STAFF REPORT: 06/14/2023 MEETING

APPLICATION NUMBER: 23-8400

ADDRESS: 535 ARDEN PARK

SCOPE: *INSTALL ALUMINUM CLAD WOOD WINDOWS*, APPLY WINDOW TRIM

Figures 3,4: Photographs of the original windows (left), and extant replacement windows (right) on the side elevation of 535 Arden Park. The red arrow indicates the wood pieces the proposed project aims to replicate.

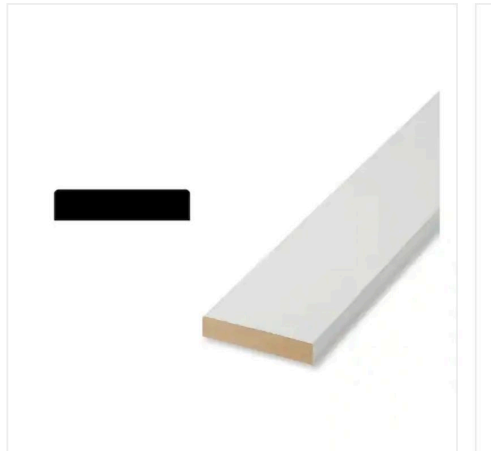
- The wood “trim” pieces visible in the pictures prior to the window replacement appear to be associated with a former storm window system and were not an integral part of the original windows.
- The gaps visible between the windows at the window banks are due not to a lack of window trim, but instead to the fact that the replacement windows are paired units, while the original configuration consisted of four individual units divided by mullions.

- It is staff’s opinion that the limestone windowsills were likely originally unpainted. Generally speaking, applying common house paint to stone is an inappropriate treatment that can lead to accelerated deterioration.
- The proposed applied trim does not remediate the window replacement previously deemed inappropriate by the Commission. The wood trim seen in the “before” photographs was part of a storm window installation, and not integral to the original windows.

The proposed applied trim and painting of the window sills does not mitigate the inappropriate nature of the replacement windows.
